## FINAL REVIEW CITY OF ALLENTOWN, PENNSYLVANIA HARB July 12, 2019

Case # HDC-2019-00018 – Proposal to do façade improvement, restoration and rehabilitation

Property located at: 244 N 10th Street Agenda #4 Historic District: Old Allentown Case # HDC-2019-000018 Meeting date: July 1, 2019 Property Owner: Luis Felipe & Yanira De Roche Owners Address: 244 N 10<sup>th</sup> St, Allentown, PA 18102 Applicant: Peter Lewnes Applicant's Address: CADCA 523-525 N 7<sup>th</sup> St, Allentown, PA 18102

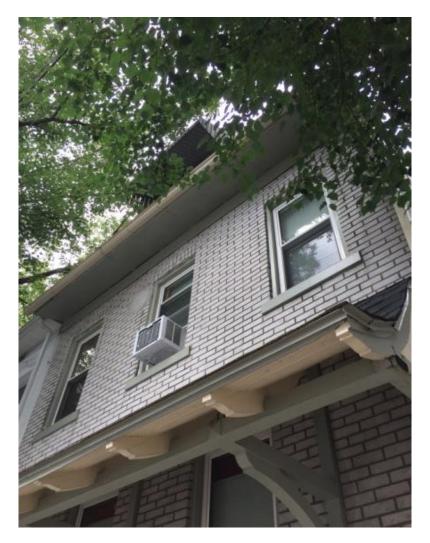
**Evaluation, effect on historic district, recommendations**: The proposed work is historically appropriate with the following clarifications or recommendations:

- Remove existing brickote with gentlest means possible to limit damage to historic brick. Follow Preservation Brief #2 for repointing using a high lime content mortar
- It is recommended to remove all windowsill and trim capping. Replacing vinyl replacement windows with 1/1 Aluminum clad wood windows is highly recommended if financially feasible
- Installation of specified storm door is historically appropriate.
- All other items are historically appropriate with staff approval where necessary

- a. Brickote and stucco water table will be removed, and historic brick repointed with high lime content mortar as needed. Preservation Brief #2 is to be followed

- b. The existing roofing will be repaired or replaced with natural slate or new GAF Slateline fiberglass shingles (or equivalent)
  - c. The existing vinyl windows may be retained or replaced with 1 over 1 aluminum clad wood windows.

- d. The existing storm door frame will be removed and a new a bronze full light storm door and frame installed.
  - e. It is recommended to remove the existing window casing and sill capping and to repair and repaint original wood casing and sills if possible.

- f. The aluminum awning on the 3<sup>rd</sup> floor dormer will be removed.
  - g. Louvered wood shutters will be installed on the second floor windows utilizing existing hardware.

- h. Repair or recast and reinstall the coal grate in porch. Install a new window behind coal grates if needed.
  - i. All woodwork and dormer will be repaired in-kind and painted.

- j. Existing downspout will be painted or replaced with new painted round downspout, if needed
  - k. All iron work will be painted flat black.
  - I. Street address will be added to the door frame or transom
